Title: **LOS Coil Driver**
 LIGO Laboratory
 California Institute of Technology
 Massachusetts Institute of Technology
 LIGO

Size: D DCC Number: D000325 SCH / PCB Revision: B1 Engineer: J. Heffner Date: 2/4/03
 File: E:\hcal\lucasson\l_losdriver\revB1\l_losdriver\revB.Sch Time: 14:55:39
 Sheet 3 of 3

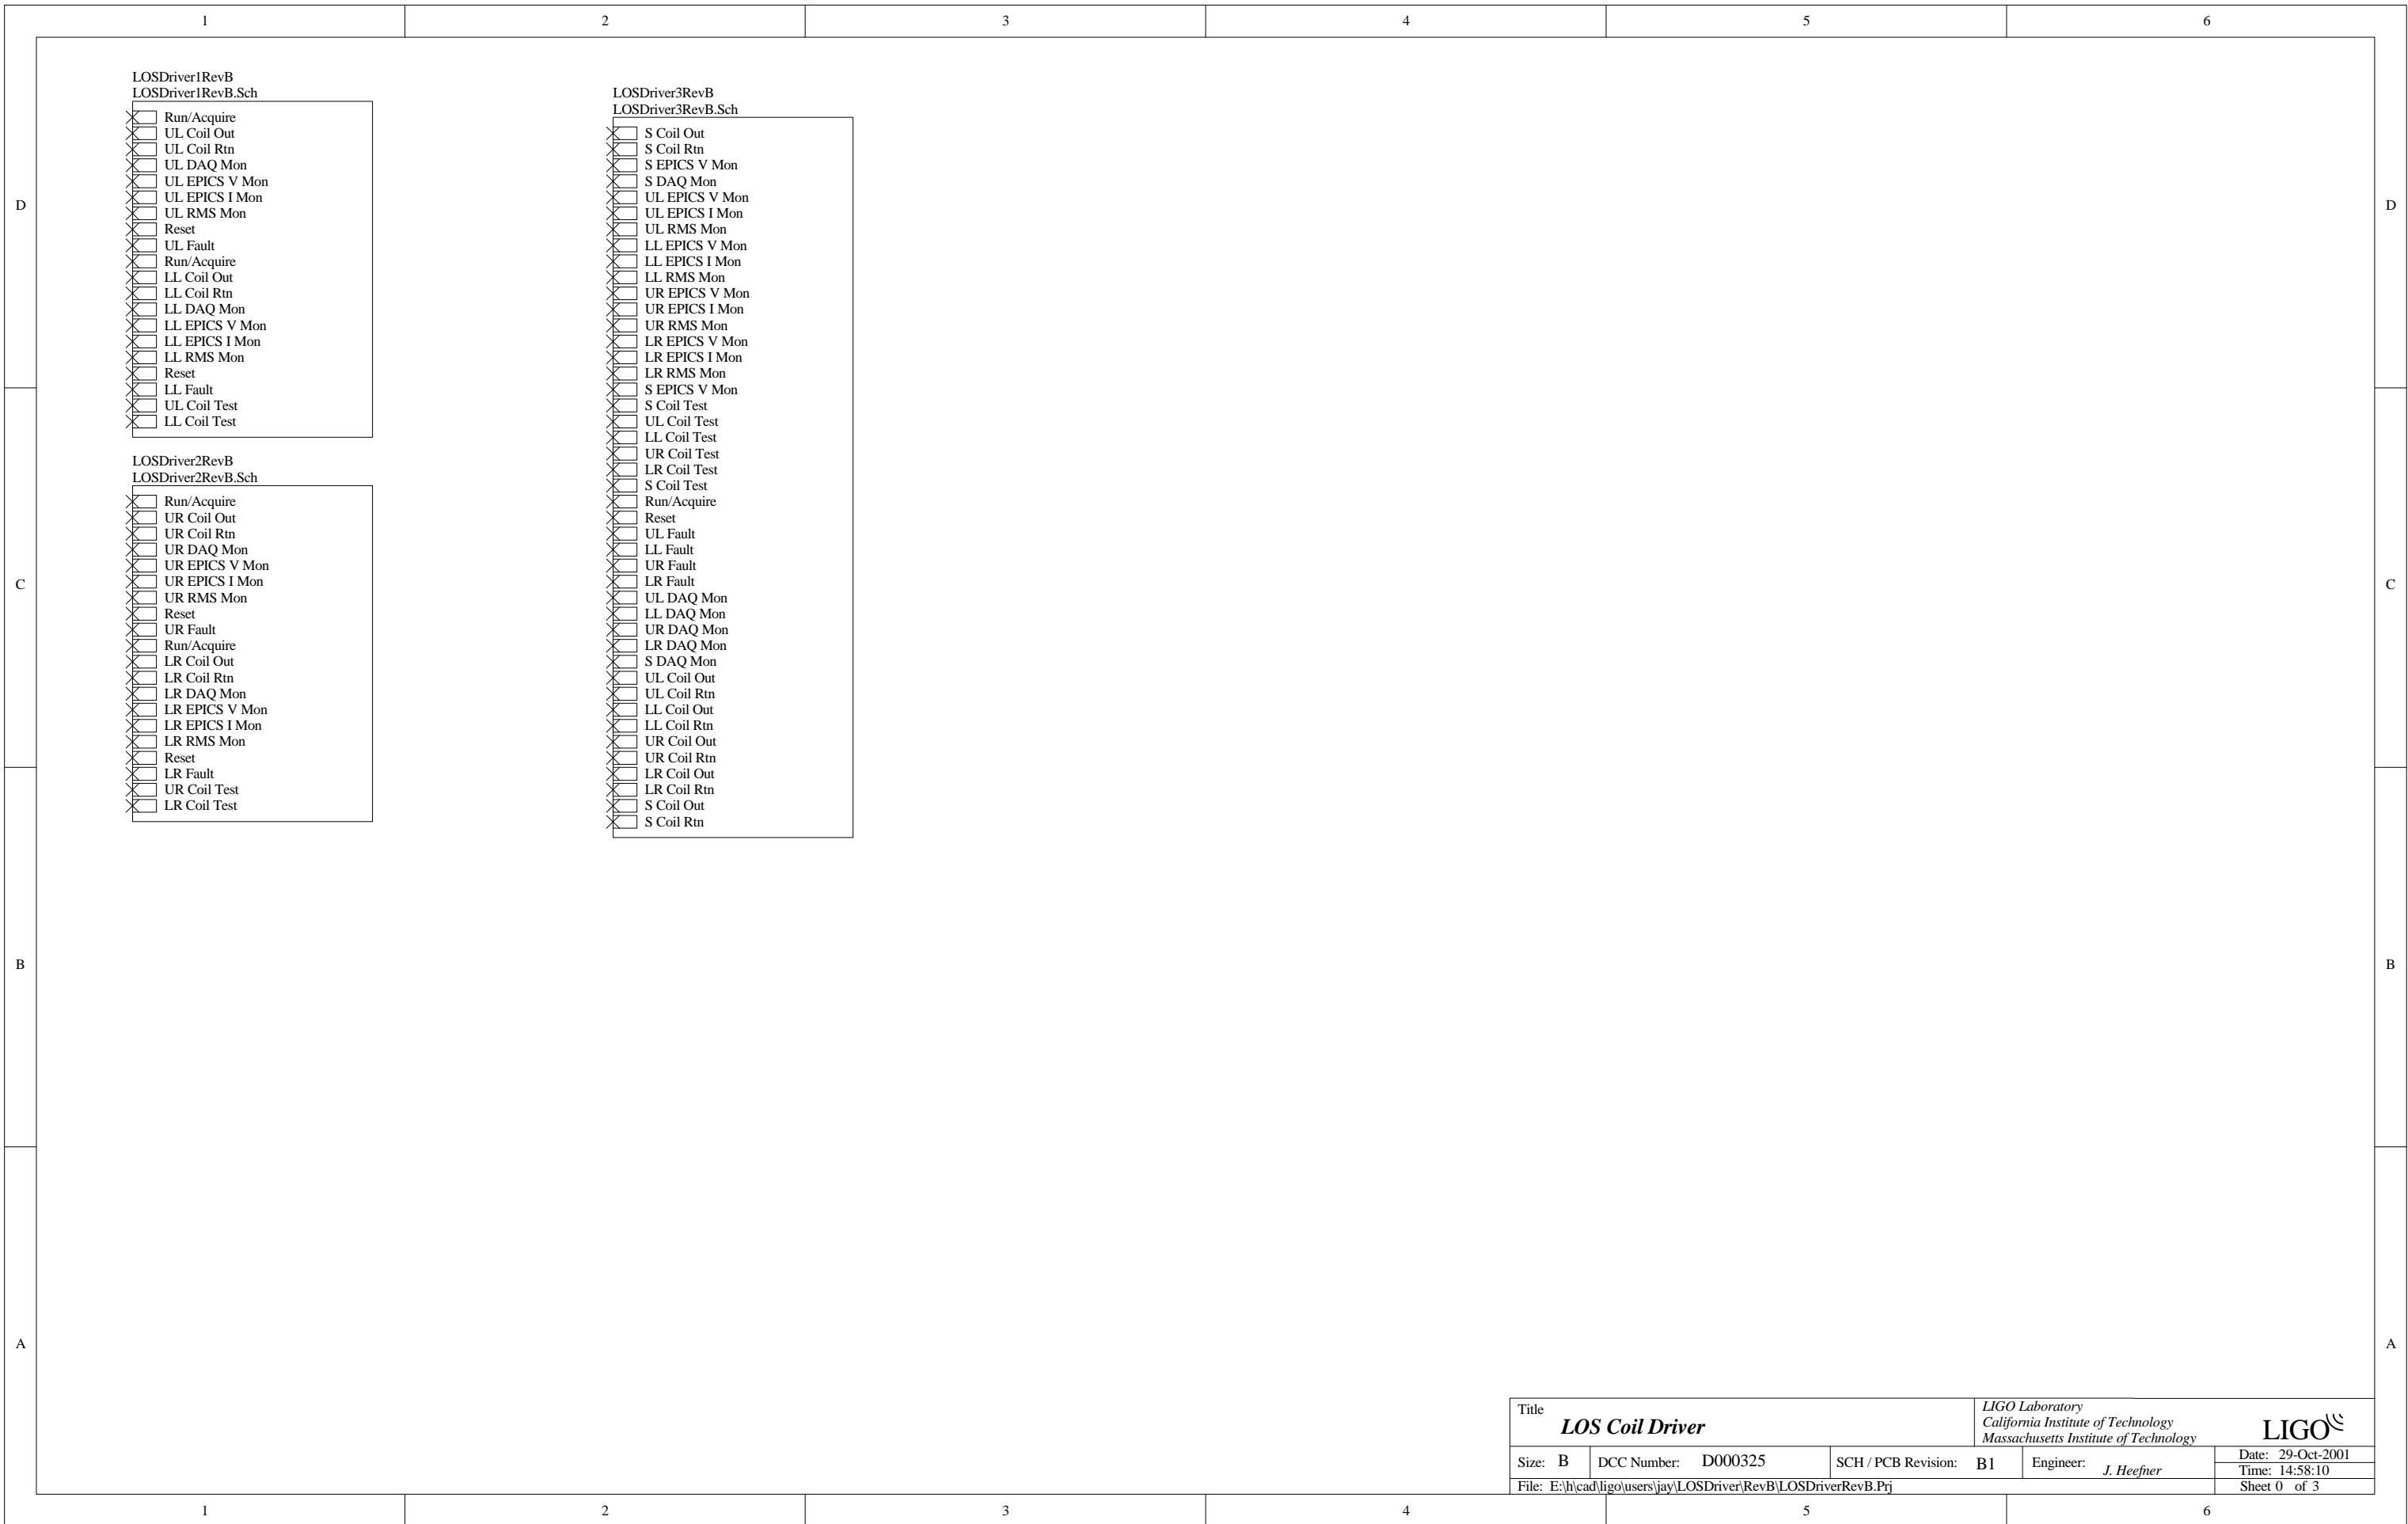
Rev	Description	Date
A	Initial Release	10/00
B	1. Changed connection of K5 to correct polarity for coil (Pins 1&6 reversed) 2. PCB traces rerouted for K5 and C64. 3. Hole sizes for PAR5s increased to allow sockets. 4. J12 rotated on PCB.	6/01
B1	Swapped pins 10 and 12 on relays K1, K2, K3, K4 and K5 to invert enable signal. Change was done by removing relays from board and adding an interface socket to make the switch.	10/01
